Subject: AP1000 Response to Request for Additional Information (TR 85)

RAI-TR85-SEB1-10 R3

AP1000 TECHNICAL REPORT REVIEW

RAI Response Number: RAI-TR85-SEB1-10
Revision: 3

Figure RAI-TR85-SEB1-10-1 – Passive Pressure versus Deflection at Grade (North-South Excitation)

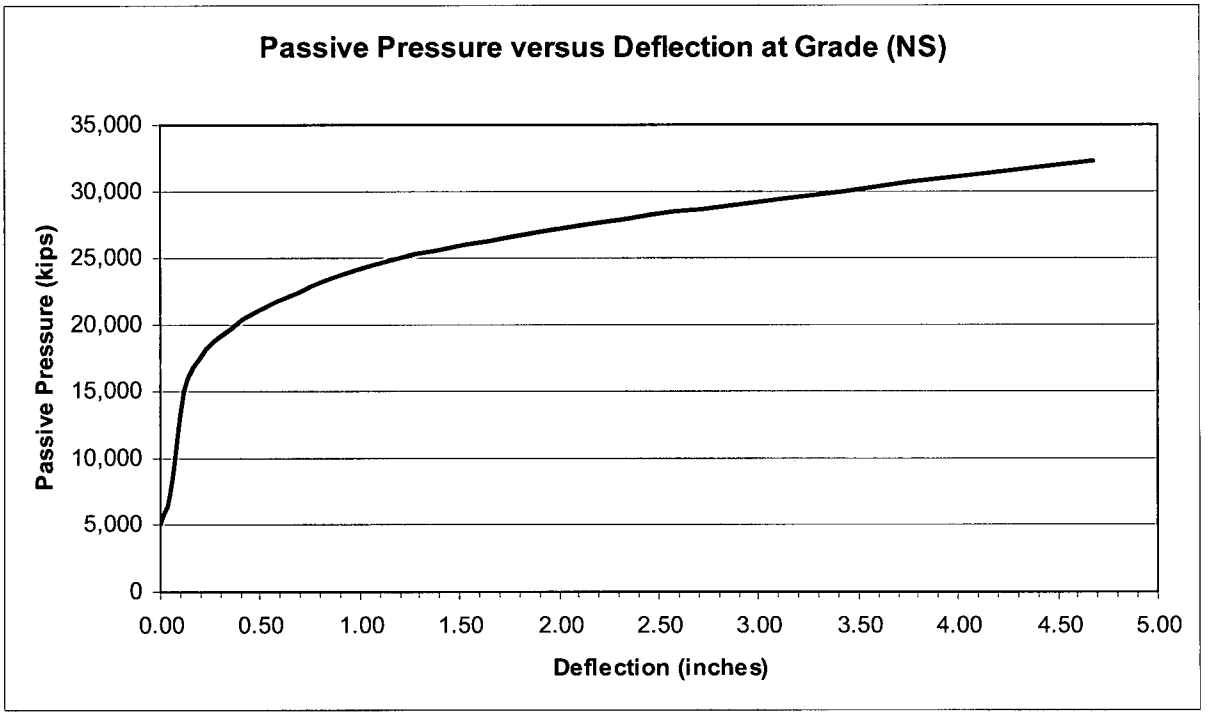
In the response for item b of the RAI, Westinghouse indicated that the analysis for stability has been revised to utilize the 3D ANSYS finite element NI20 model using a mode superposition time history analysis (linear with no lift-off). A separate 2D ANSYS lift-off analysis demonstrated that the minor lift-off is negligible. Since the 3D ANSYS NI20 model analysis using three input motions applied simultaneously is utilized for the stability evaluation, the concern raised by the directional combination methods no longer applies. Therefore, this concern has been adequately addressed. However, the RAI response discussed the need to utilize some passive pressure resistance capability of the soil when performing the sliding stability analyses. The passive pressure resistance curve as a function of displacement is based on Reference 1 (Hsai-Yang Fang, "Foundation Engineering Handbook," 1991) given in the RAI response. Westinghouse is requested to provide the complete text in the applicable section or chapter of the referenced book which describes the approach for determining the passive pressure resistance function.

In the evaluation of sliding different coefficients of friction are considered. They are 0.7, 0.6, and 0.55. Also, it is necessary to rely on passive pressure. Using Case 15 (RAI-TR85-SEB1-35, R1, Table RAI-TR85-SEB1-35-1), and the methodology given in Reference 1 using a soil friction angle of 35°, a relationship between passive pressure and displacement at grade elevation can be defined. This relationship is shown in Figures RAI-TR85-SEB1-10-1 and RAI-TR85-SEB1-10-2 for the first 5 inches of deflection. Curves are given for the North-South and East-West directions. The passive pressure at zero deflection is equal to the at rest pressure. The total passive soil pressure resistance force is 43,500 kips for the North-South direction, and 69,100 kips for the East-West direction. It is noted that to achieve the full passive pressure displacements in excess of 10 inches are required.

During the sliding stability calculation it was determined that the factor of safety for sliding drops below the limit of 1.1 for a very short time if passive pressure is not considered. Plots of the factor of safety (FS) versus time for the hard rock case and the North-South and East-West directions are given in Figures RAI-TR85-SEB1-10-3 and RAI-TR85-SEB1-10-4 using a coefficient of friction of 0.55. As seen from these figures the time at which the factor of safety drops below 1.1 is very short. This is the only time during the seismic event that this occurs. When the passive pressure is considered, the factor of safety remains above the limit of 1.1.
